From: WELLS Russell D (AREVA NP INC) [Russell.Wells@areva.com]
Sent: Friday, April 17, 2009 10:39 PM
To: Getachew Tesfaye
Cc: Pederson Ronda M (AREVA NP INC); BENNETT Kathy A (OFR) (AREVA NP INC); DELANO Karen V (AREVA NP INC)
Subject: Response to U.S. EPR Design Certification Application RAI No. 130, FSAR Ch 3, Supplement 2 <a e>
Attachments: RAI 130 Supplement 2 Response US EPR DC.pdf

Subject: Response to U.S. EPR Design Certification Application RAI No. 130, FSAR Ch 3, Supplement 1

QUESTIONS for Structural Engineering Branch 2 (ESBWR/ABWR Projects) (SEB2)

Figure 3E.3-3—Reinforcement Sketch for ESWB Basemat Foundation

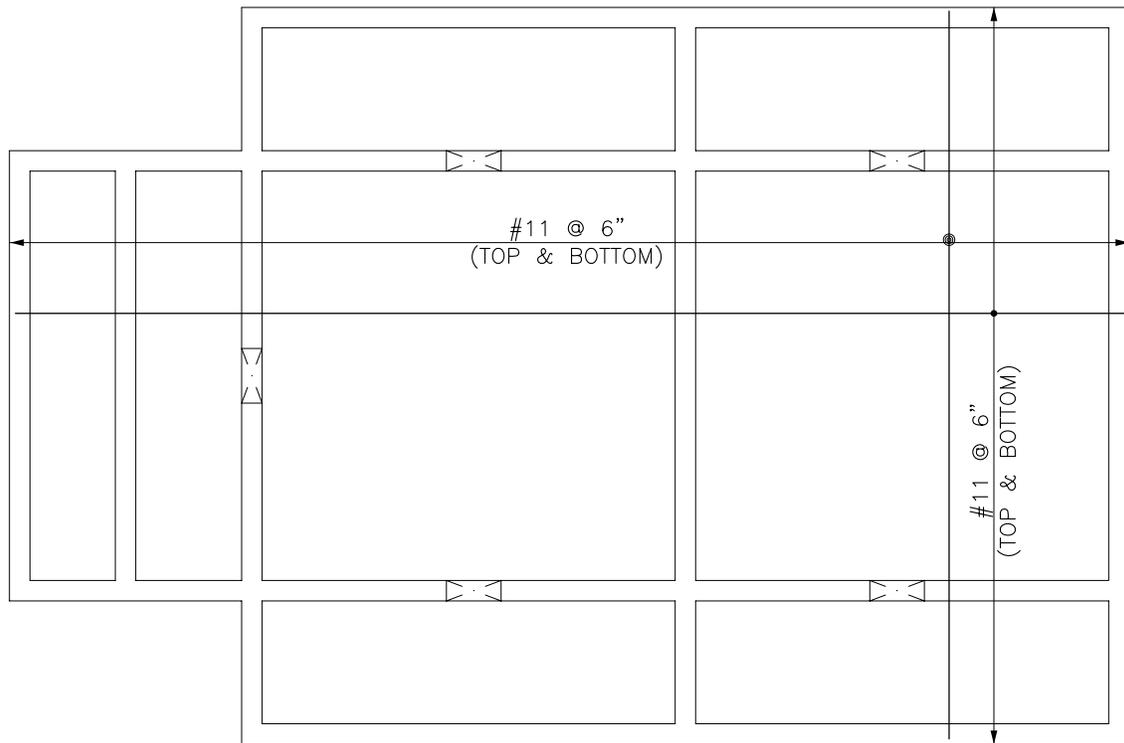
As noted in U.S. EPR FSAR Tier 2, Section 3E.3.1, ten feet extension of the basement slab beyond the building walls was not included in the soil-structure interaction (SSI) analysis. This was added during the preliminary design to resist overturning moment. Subsequent analysis performed has demonstrated that added slab extension is not required for stability. The U.S. EPR FSAR will be revised to reflect deletion of the slab extension.

The reinforcement sketch for ESWB basemat foundation is provided as As shown in Figure 3E.3-3—Reinforcement Sketch for ESWB Basemat Foundation, ~~the basemat foundation extends an additional 10 ft – 0 inches in width on all sides of the structure.~~

U.S. EPR FSAR Tier 2, Section 3.7.2.4.6, Section 3.8.4.4.4, Section 3.8.5.1.3, Appendix 3E.3, Appendix 3E.3.1, Table 3E.3.1, Figures 3.8-95, 3.8-101, 3.8-102, 3B-69, 3B-75, 3B-76, 3E.3.2, 3E.3-3 and 3E.3-7 will be revised as indicated on the enclosed markup. Figure 3E.3-10 will be added to Appendix 3E.

REVISED PER RAI 130 SUP 2
03.07.02-27

Figure 3E.3-10—Orientation of Positive Axis

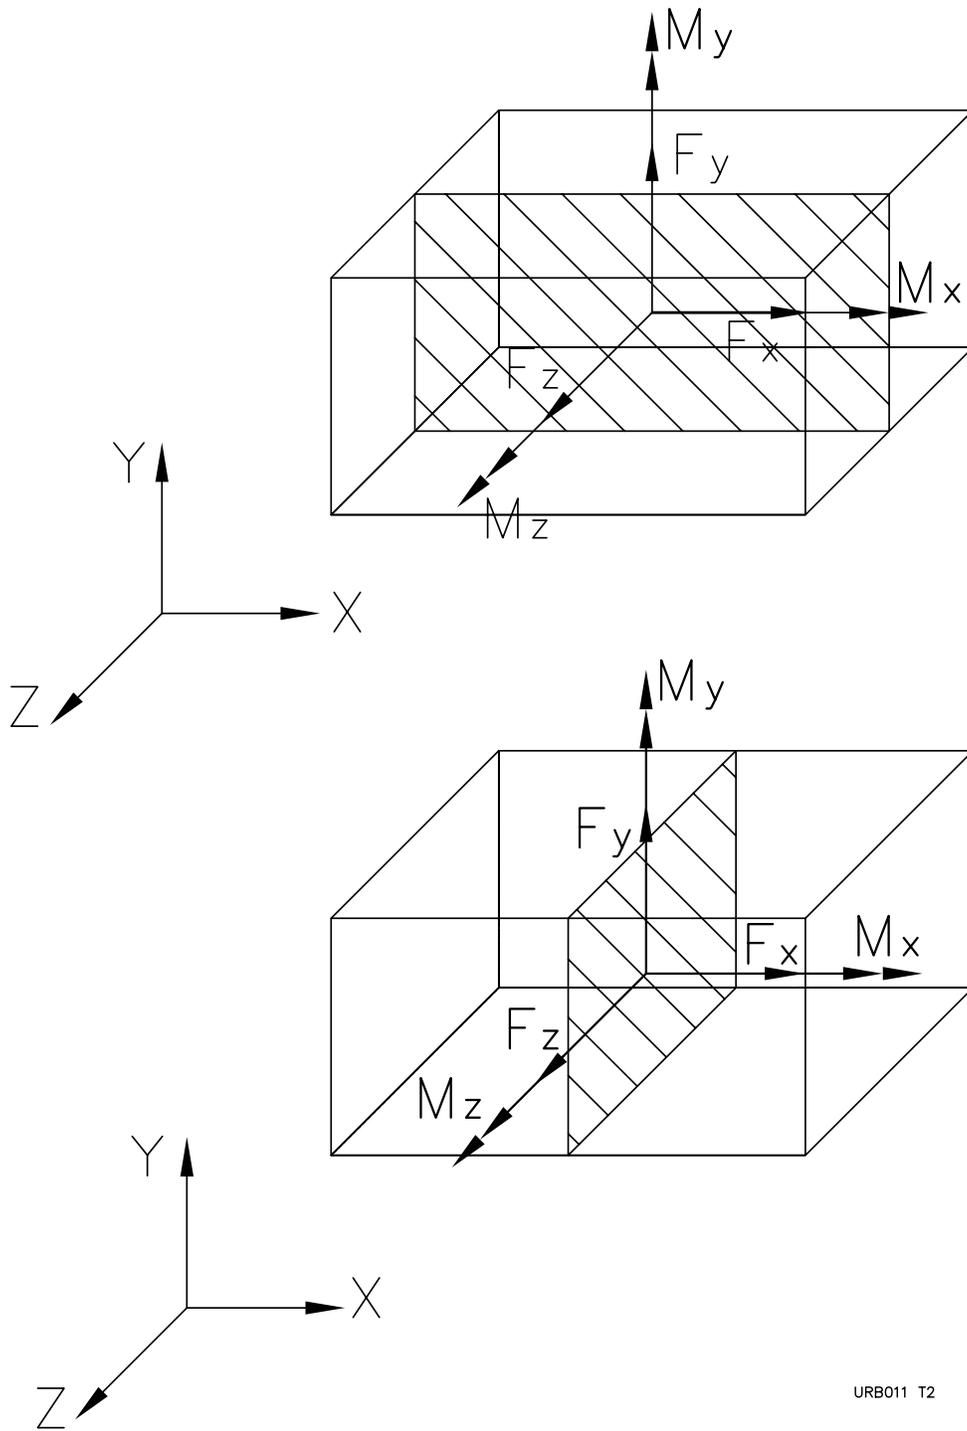
foundation. The section cuts locations are shown in Figure 3E.3-2—ESWB Basemat Foundation—FEM. The sign convention describing the nomenclature for horizontal and vertical cuts applicable to this critical section is shown on Figure 3E.3-10.
